10/814,427

Office Action Summary

DETAILED ACTION

Fig. 1

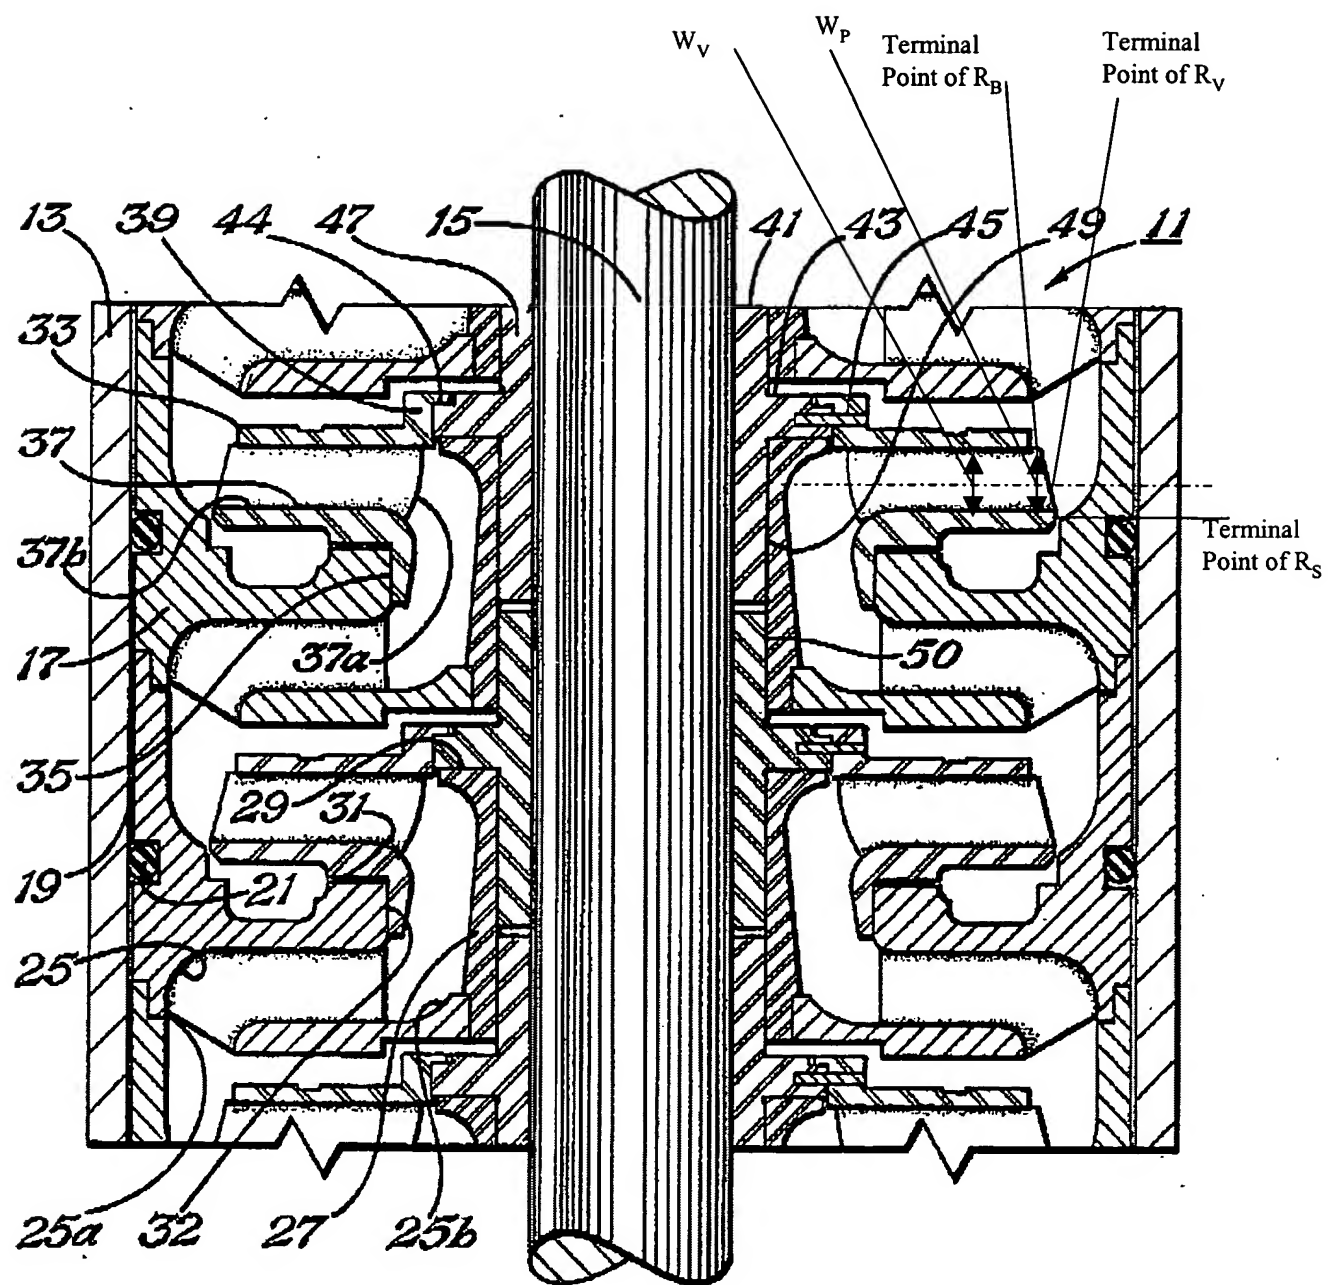
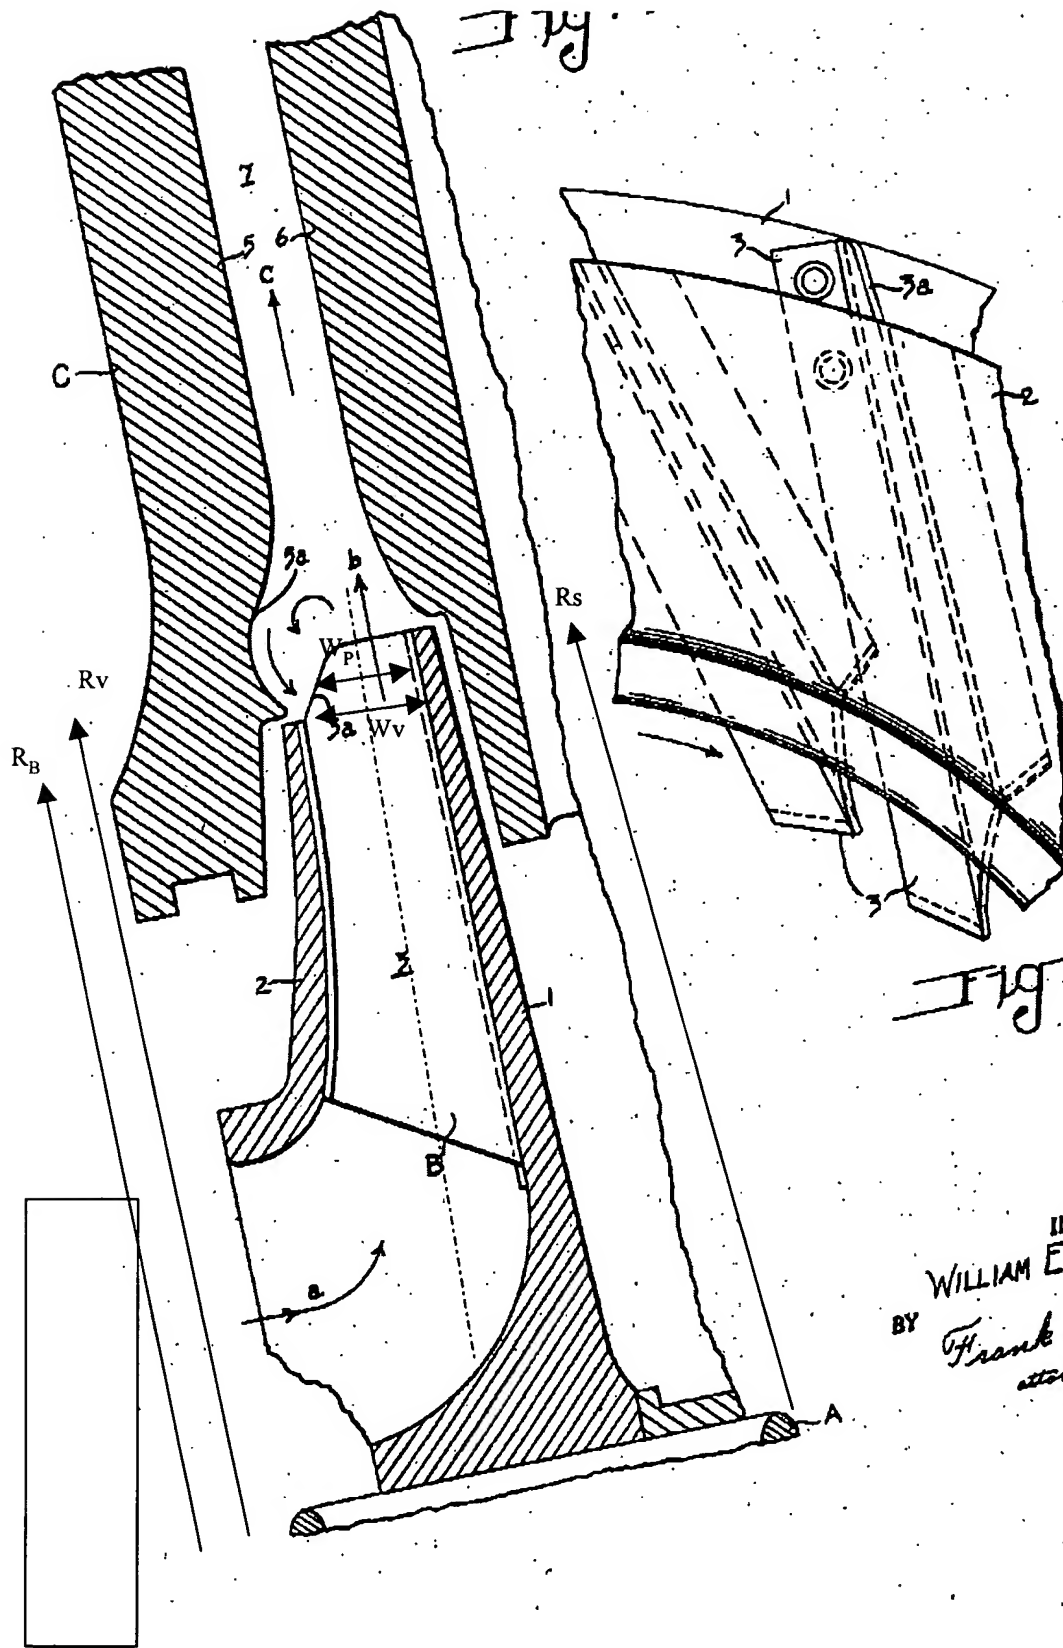
Trumpler discloses an impeller (Figs. 1, 2) comprising at least one vane 3 extending radially in length from near a central axis of the impeller to an outer peripheral edge of the impeller and having a centerline extending along the radial length which is perpendicular to the central axis of the impeller (see marked up Fig. 1 at the end of this Office Action) and the at least one vane having an outer terminal end at or near the peripheral edge of the impeller, the outer terminal end having an outwardly extending portion being convex-like shape (edge 3a);

wherein the impeller further comprising at least one shroud 1 having a peripheral edge defining the peripheral edge of the impeller, the at least one vane 3 extending outwardly from the shroud (Fig. 1);

wherein the outwardly extending portion has a terminus and a radius R_v (see marked up Fig.1) measured from the central axis of the impeller to the terminus, and wherein the shroud has a radius R_s , measured from the central axis to the peripheral edge, wherein R_v is greater than R_s ;

wherein the outer terminal end of the at least one vane further comprises a portion having a radius R_B where R_B is equal to R_s (see marked up Fig. 1);

wherein the outwardly extending portion is arcuate in shape (Fig. 1);

wherein the at least one vane A has a width W_v (see marked up Fig. 1) and wherein the outwardly extending portion has a width W_p where W_p is less than or equal to W_v .

Regarding claim 12, the impeller further comprising a second shroud 2 positioned substantially parallel to and spaced from the shroud and wherein the at least one vane extends between the spaced apart shroud.
